From:	Ferguson, John J. (DEC)
To:	Edwards, Kristine
Cc:	<u>Ciccone, Yvonne; Lawrence Frame (Iframe@hntb.com); Hitt, Noah; Barnett, Elena (Elena.Barnett@hdrinc.com);</u>
	john.duschang@hdrinc.com; Casper, Peter M; David Paget (dpaget@sprlaw.com); English, Diane M (DEC); Woodfield, Karen (DEC)
Subject:	RE: More Additional Dredging at TZ - Access Area Extension at
Date:	Friday, September 11, 2015 12:22:13 PM
Attachments:	image001.png

From: Edwards, Kristine [mailto:Kristine.Edwards@newnybridge.com]
Sent: Friday, August 28, 2015 12:02 PM
To: Ferguson, John J. (DEC)
Cc: Ciccone, Yvonne; Lawrence Frame (Iframe@hntb.com); Hitt, Noah; Barnett, Elena (Elena.Barnett@hdrinc.com); john.duschang@hdrinc.com; Casper, Peter M; David Paget (dpaget@sprlaw.com)
Subject: More Additional Dredging at TZ - Access Area Extension at Pier 42

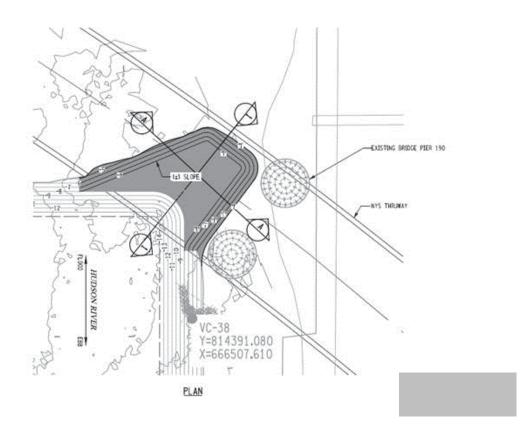
The Department has reviewed the Thruway Authority's request to extend the Tappan Zee Bridge in-water construction access area which was the subject of a June 30, 2015 permit modification. The Access Area Extension is located along the northeast corner of the Access Area, immediately adjacent to the existing Tappan Zee Bridge. The proposed additional volume to be dredged is 865 CY.

- The extension zone includes an area with surficial and near-surface concentrations of mercury among the highest encountered in this project to date (based on the 2006 and 2008 sediment surveys). As a consequence, the Department therefore considers this a new dredging area. Accordingly, water quality monitoring should be conducted as required in Permit Conditions 59-67, and not at the reduced levels previously approved for other portions of the Access Area.
- 2. Specifically, under previously-modified Permit Condition 64, dredging of the Access Area Extension is to be considered an activity for which daily water quality monitoring is required.
- 3. Previously-modified Permit Condition 27 is hereby modified to specify that the decant water holding time is 24 hours (not 12 hours) for material dredged from the Access Area Extension.

Attached you will find a letter from TZC detailing their request to extend the access area which was the subject of a modification to the permit dated June 30, 2015. As shown in the drawing below, the Access Area Extension is located along the northeast corner of the Access Area, immediately adjacent to the Tappan Zee Bridge, and occupies the footprint of of the New NY Bridge Project. Including a 1-ft overdredge, the additional volume would be **865 CY** and the additional surface area would be **0.12 acres**. This additional dredging is required to allow the installation of a precast-concrete tub at the existing bridge, instead of the previously considered cofferdam installation with cast-in-place concrete pile cap.

The Department hereby approves this modification with the following restrictions:
